BELMONT MIDDLE AND HIGH SCHOOL BUILDING COMMITTEE

SEPTEMBER 11 2019

UPDATED EXTERIOR VE ITEMS

CLASSROOM CASEWORK COST REDUCTION STRATEGY

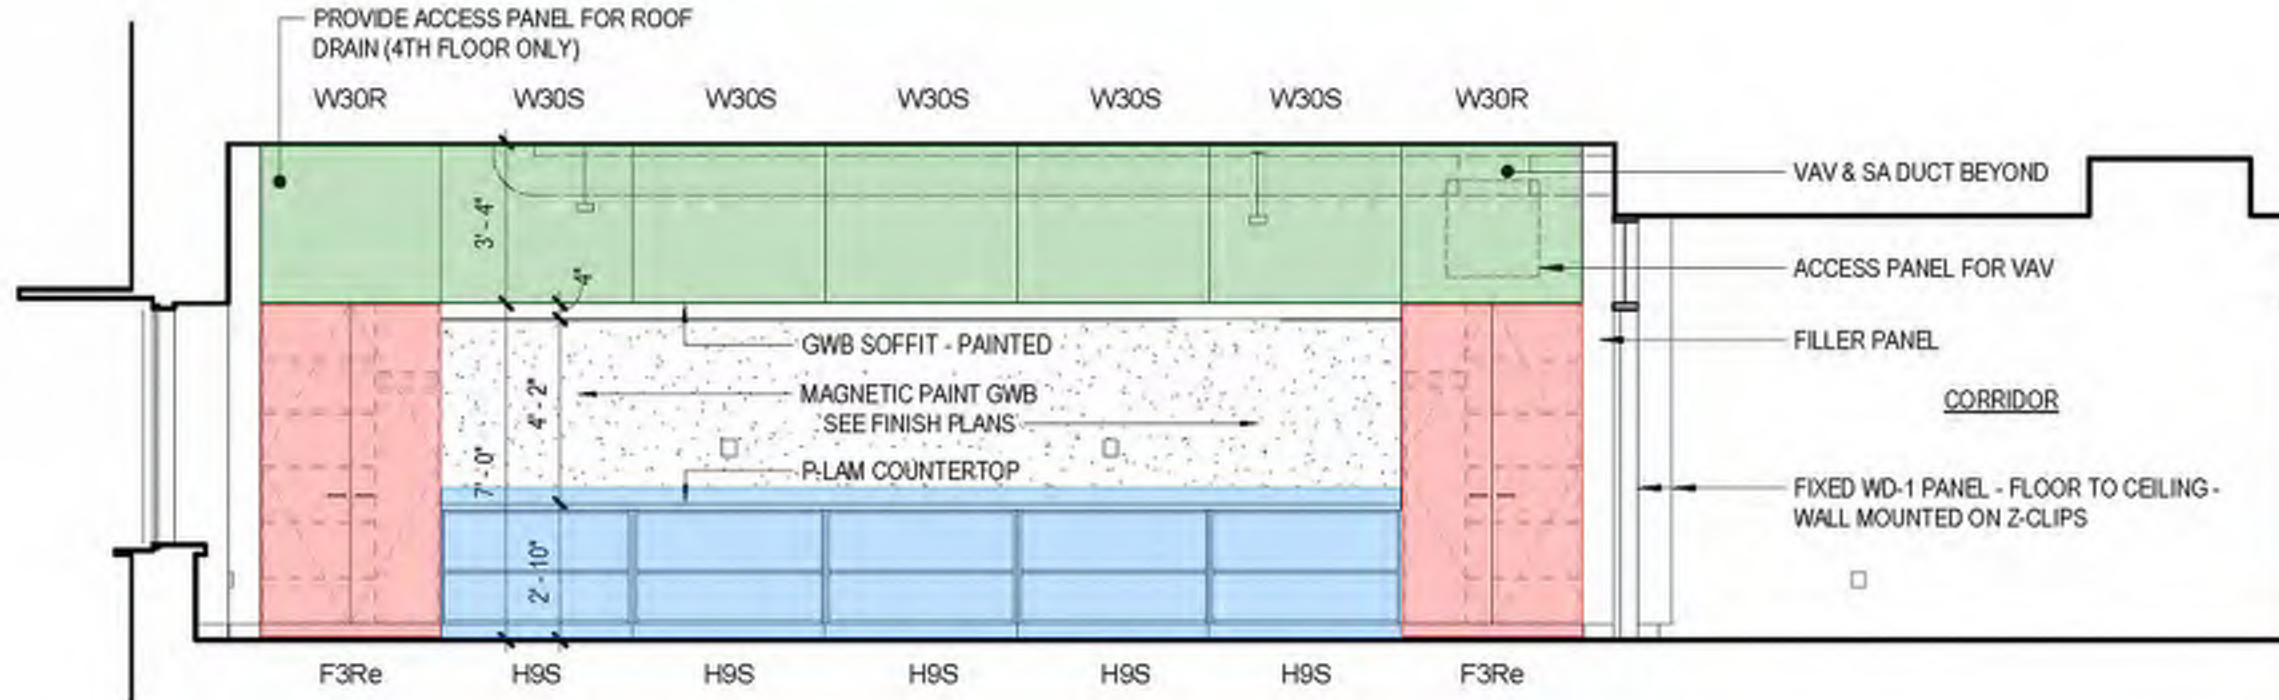
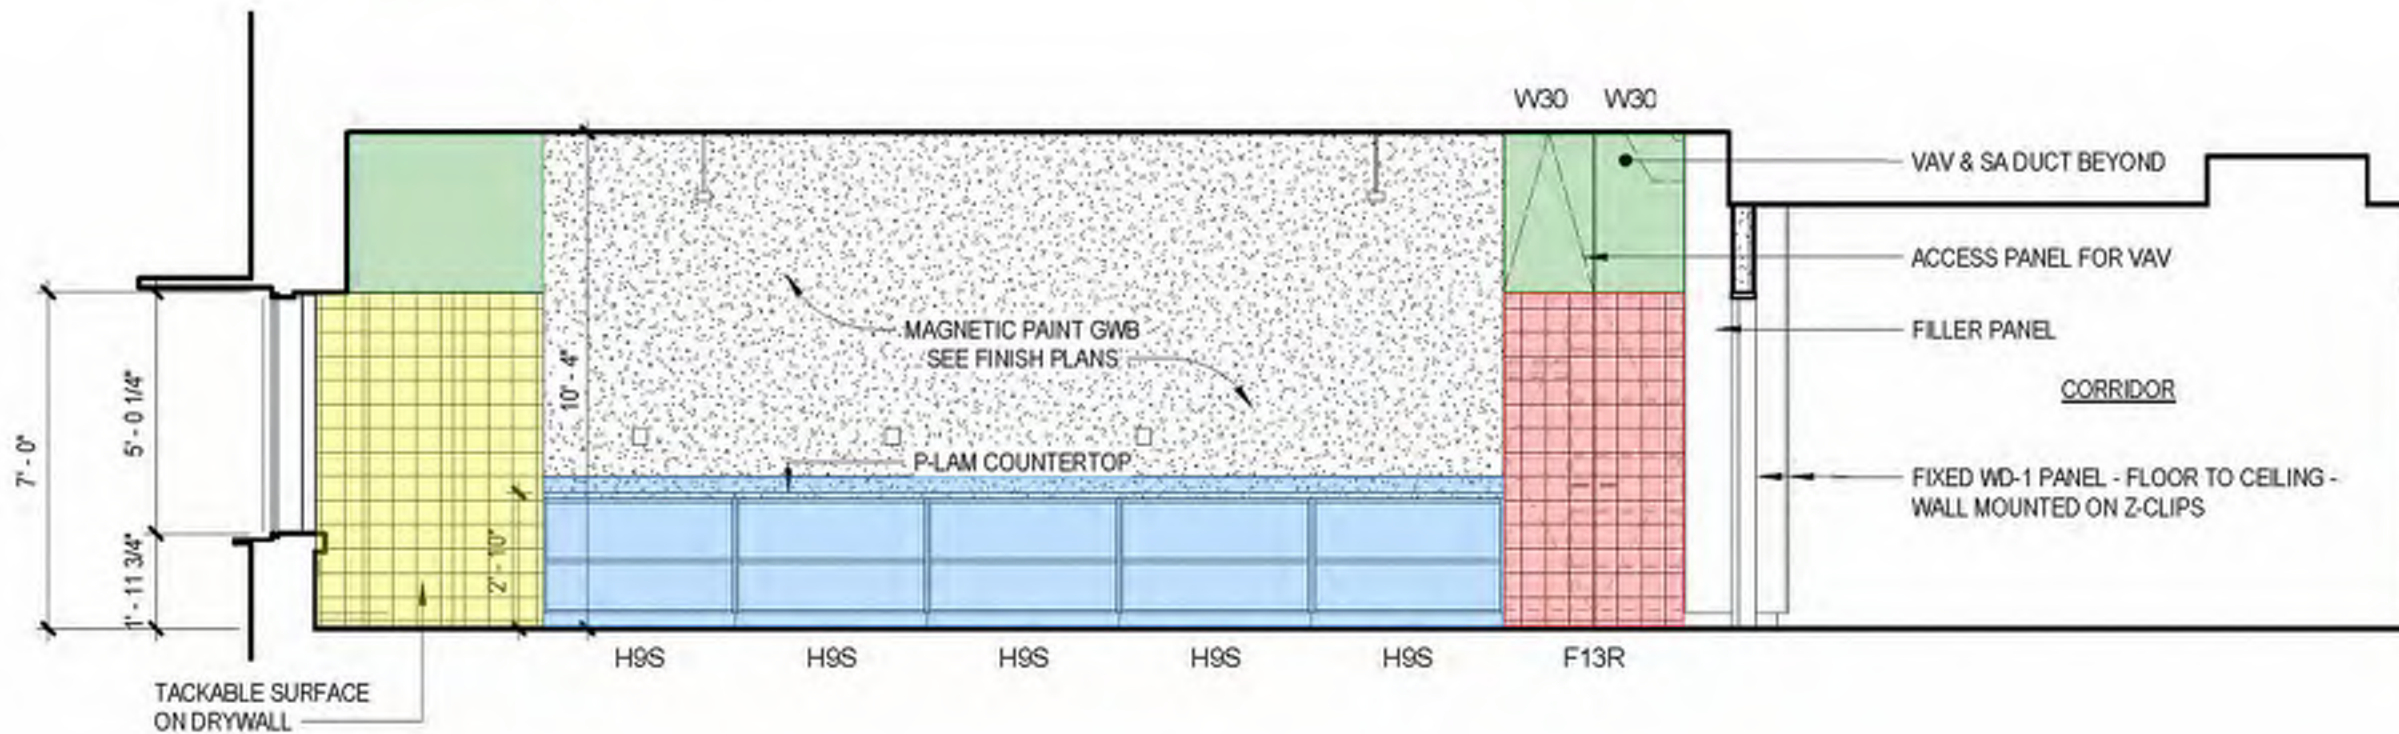
CLASSROOM CASEWORK REVISION

- 92 SQUARE FEET
- 7' - 6" LINEAR FEET
- 20' - 0" LINEAR FEET

- 28 SQUARE FEET
- 3' - 9" LINEAR FEET
- 20' - 0" LINEAR FEET
- 4' - 9" LINEAR FEET

SIMPLIFY DOMESTIC WATER PRE-HEAT & STORAGE SYSTEM

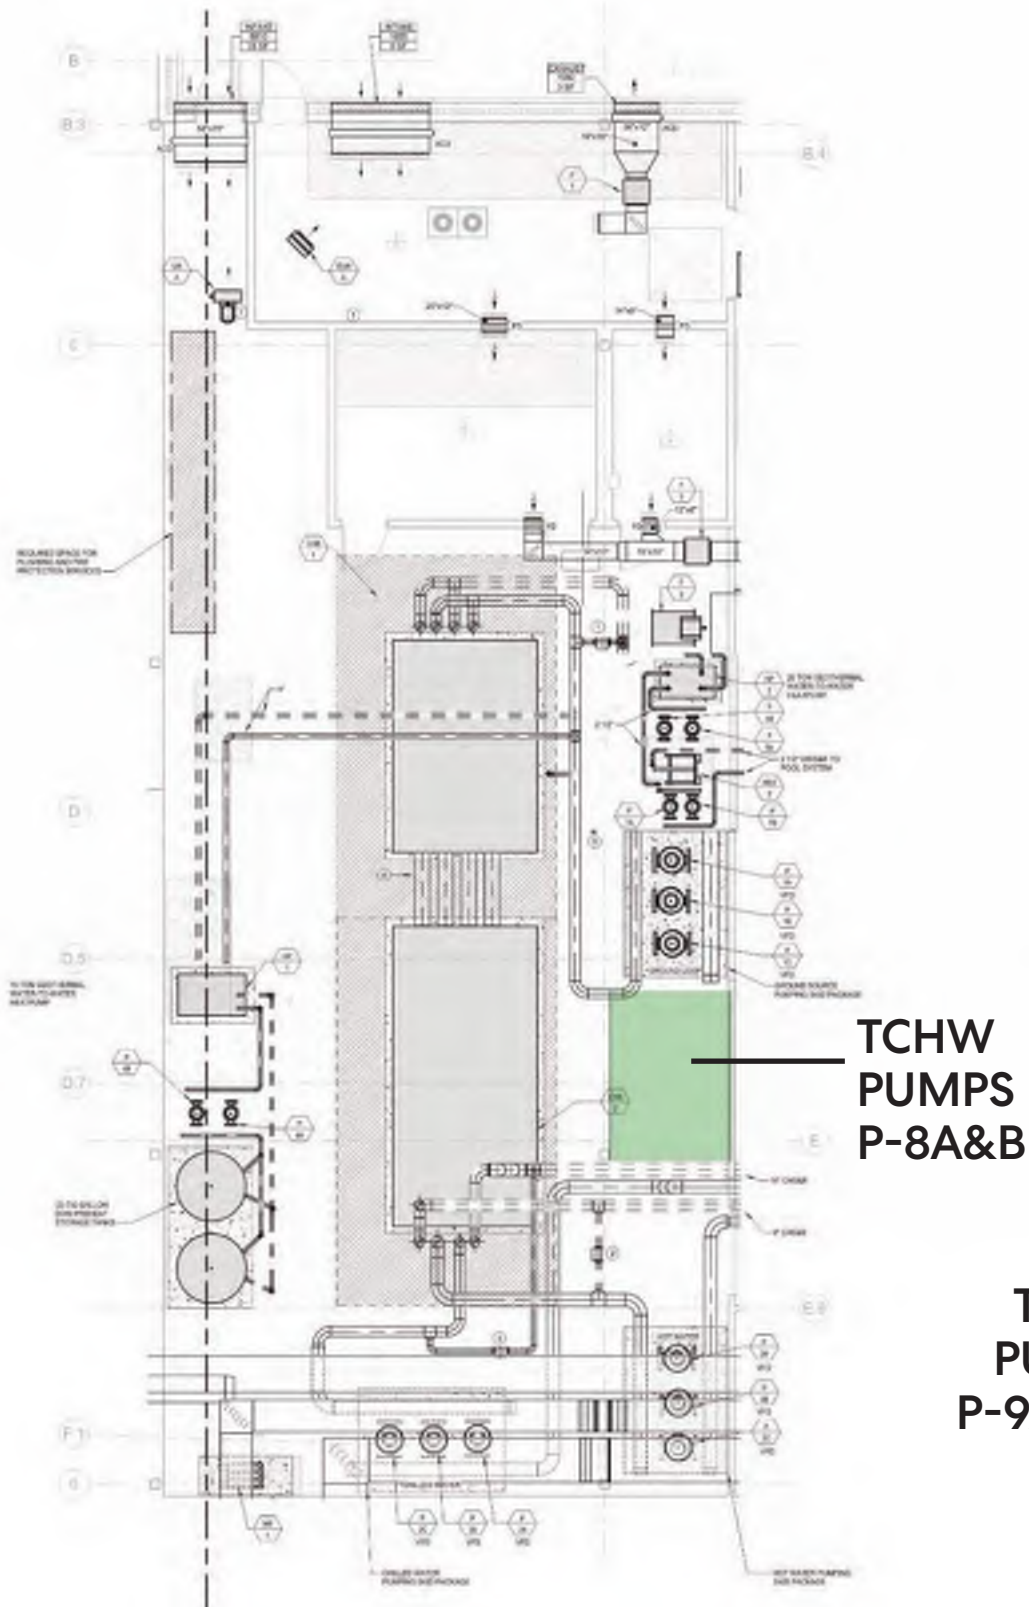
DOMESTIC WATER HEATERS THAT WILL HAVE PRE-HEATED WATER

POTENTIAL TO ELIMINATE PRE HEAT WATER (CALCULATIONS ARE STILL BEING DONE TO DETERMINE IMPACT ON ELECTRICAL LOAD IMPACT).

RELOCATE TCHW PUMPS P-8A&B AND TCHW PUMPS P-9A&9B FROM ROOF TO MECHANICAL AND PLUMBING ROOMS ON LEVEL 1

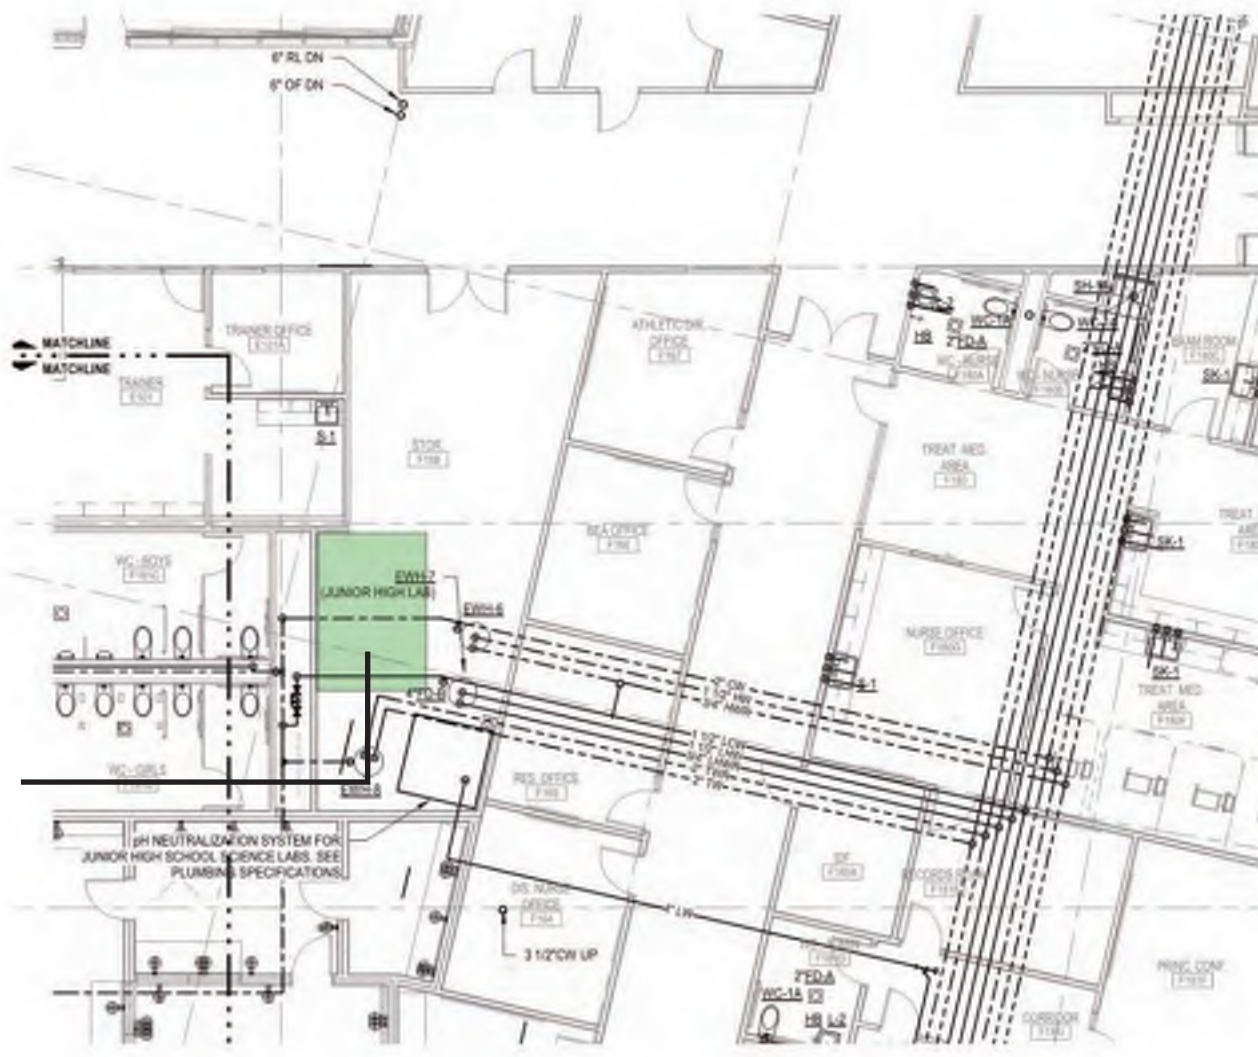
TCHW PUMPS P-8A&B

TCHW PUMPS P-9A&9B

UTILIZE DUCTLESS CEILING CASSETTE VRF FAN COIL UNITS IN LIEU OF DUCTED AT LI ADMIN SUITES IN MIDDLE AND HIGH SCHOOLS

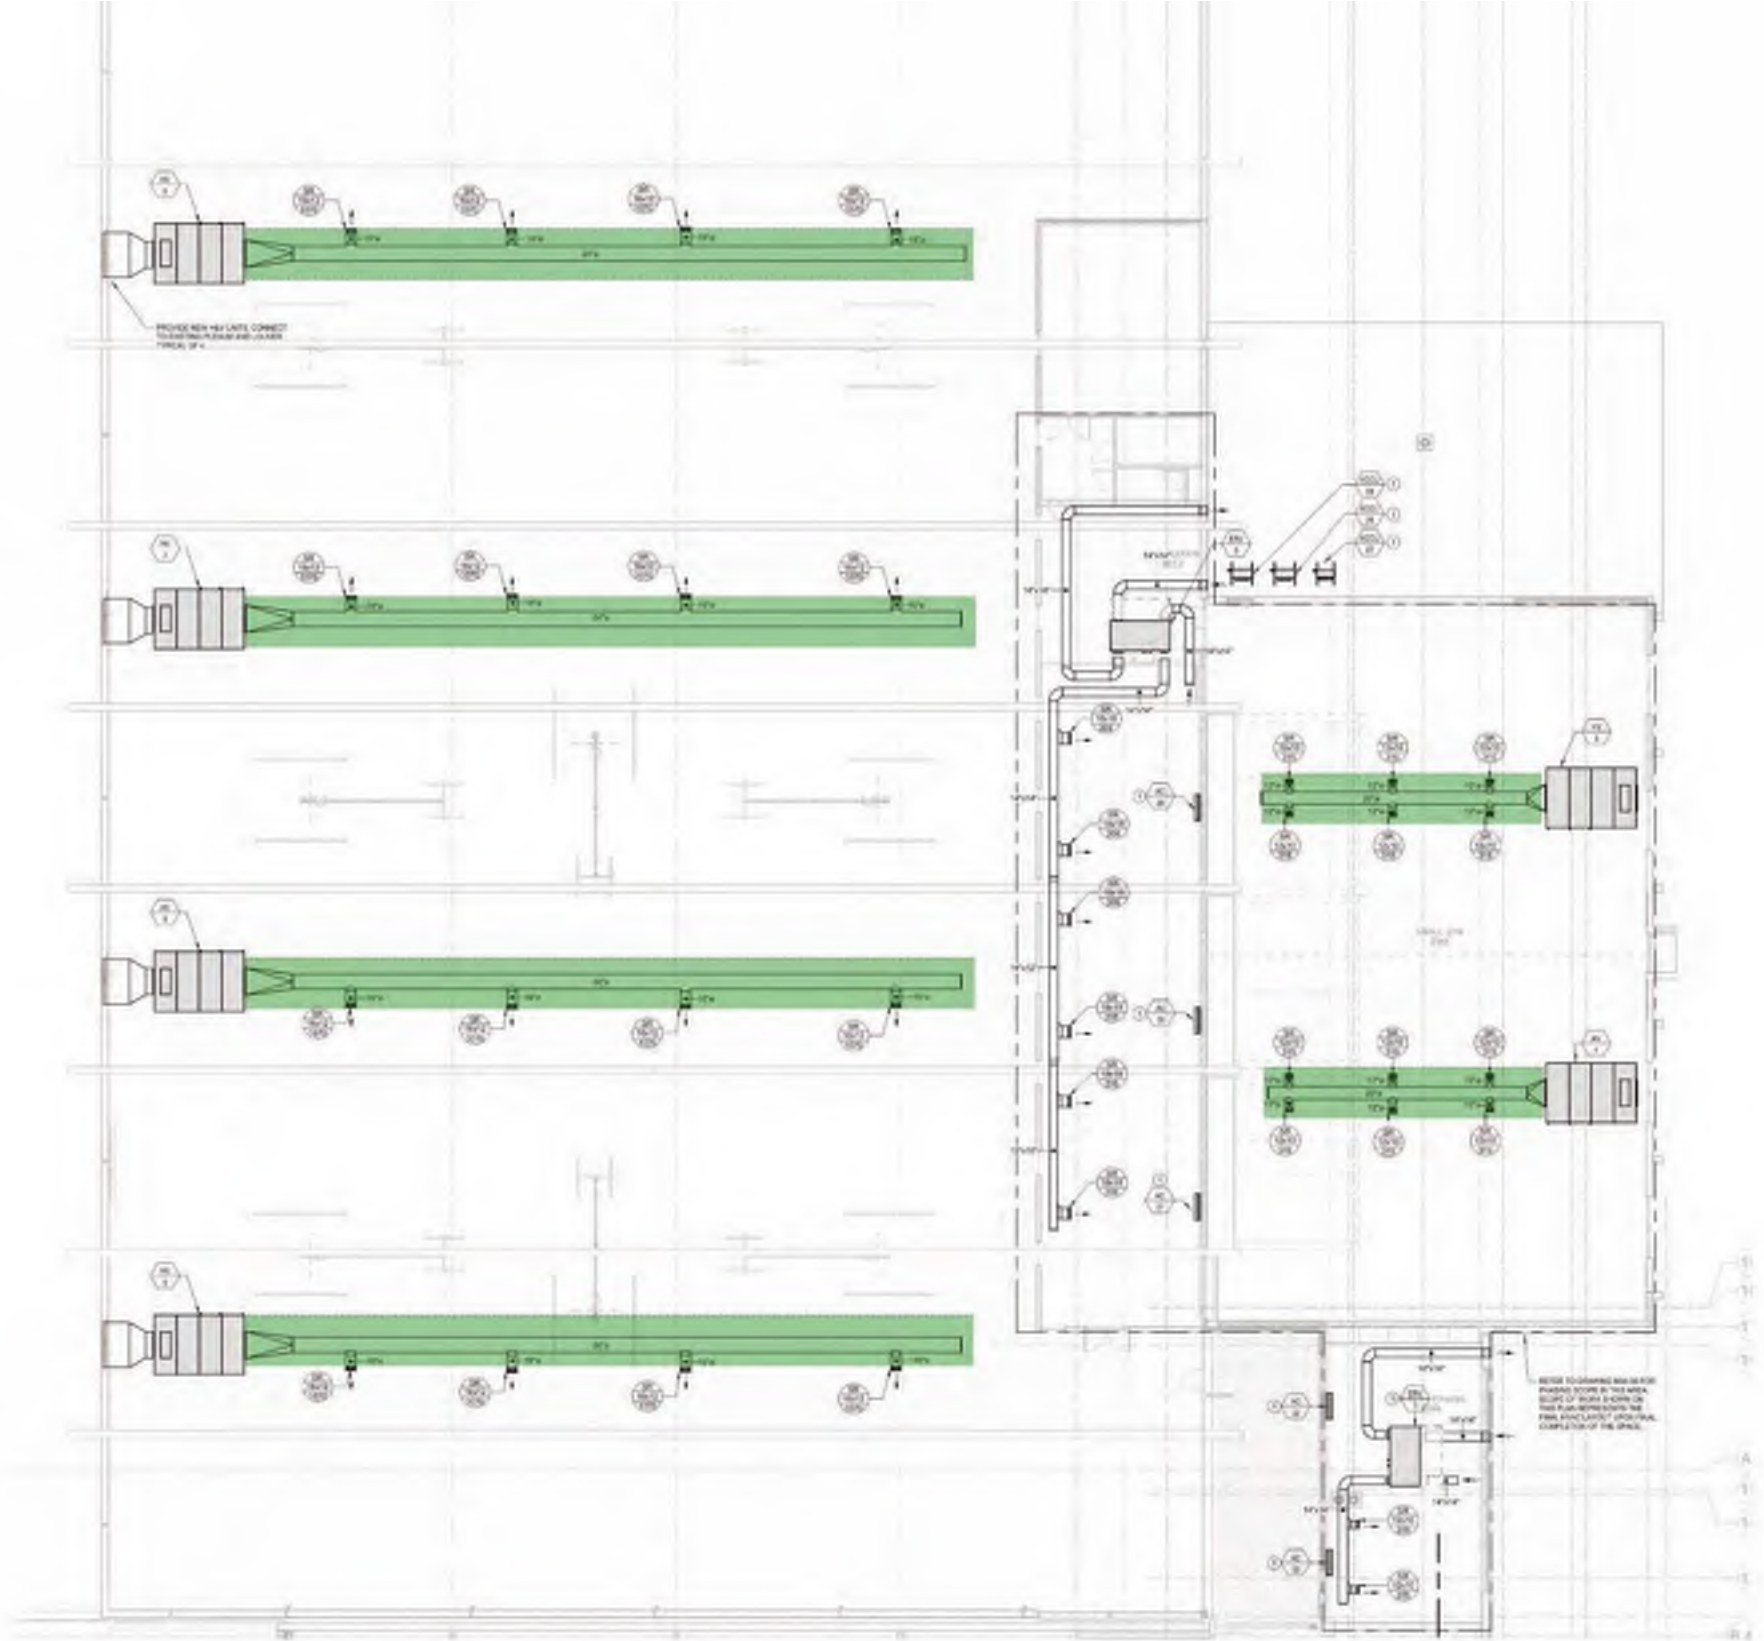
**USE SINGLE CEILING CASSETTE WITH OUTSIDE AIR DUCT.
REMOVE DUCTED FAN COIL UNIT, DUCT, AND DIFFUSERS.**

**USE (2) SINGLE CEILING CASSETTE WITH OUTSIDE AIR DUCT.
REMOVE DUCTED FAN COIL UNIT, DUCT, AND DIFFUSERS.**
